**Addendum No. 1
To Plans, Contract Documents and Specifications**

**Addison Airport – Wing Aviation and Claire Chennault Street Driveway Reconstruction
Bid No. 18-22**

DRAWING NUMBER
G-101
SHEET NUMBER
1

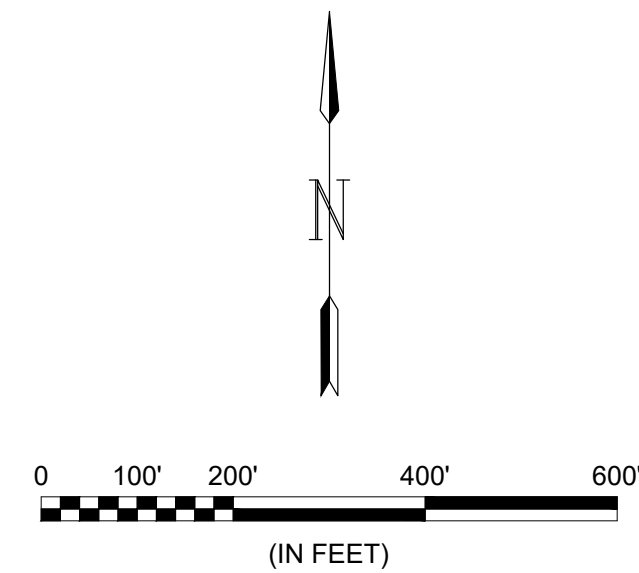
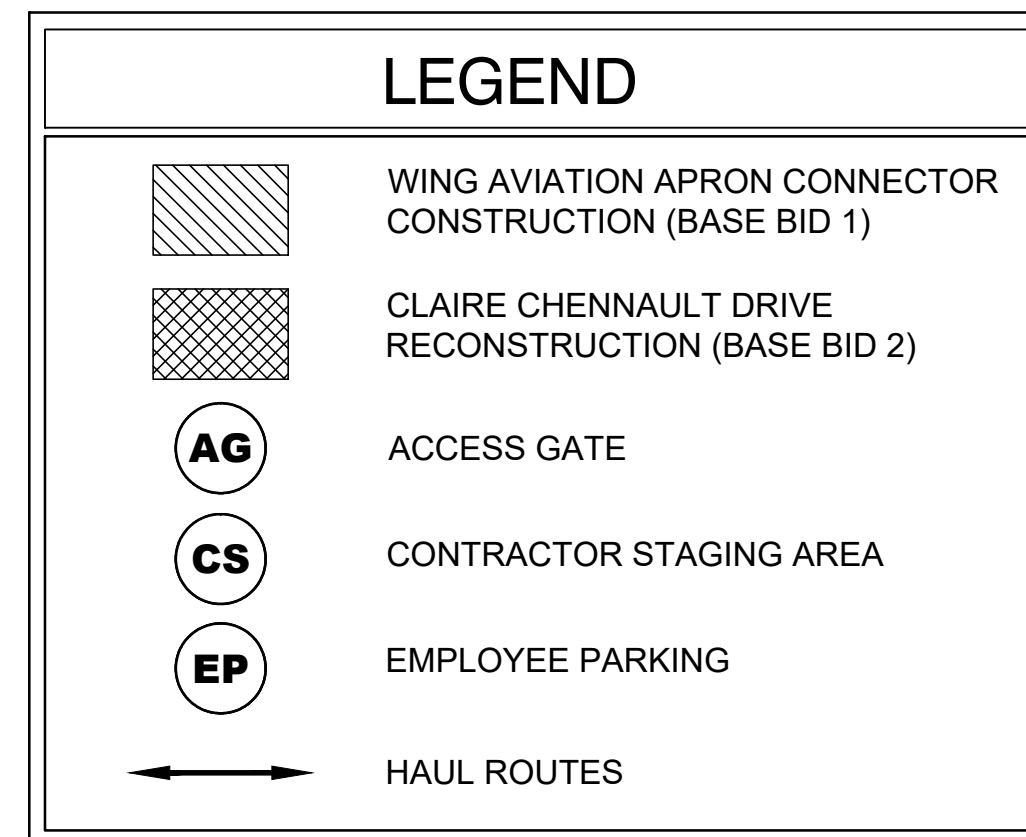
1. **Replace plan sheet G-101 Cover Sheet in its entirety with the G-101 Cover Sheet (Addendum No. 1) attached. Major Changes Include:**
 - a. Revised Earthwork Table to correct the names of the work areas in which the earthwork quantities are derived from.

EARTHWORK QUANTITIES		
WORK	CUT (C.Y.)	FILL (C.Y.)
WING AVIATION APRON CONNECTOR CONSTRUCTION	142	76
DITCH GRADING	176	200
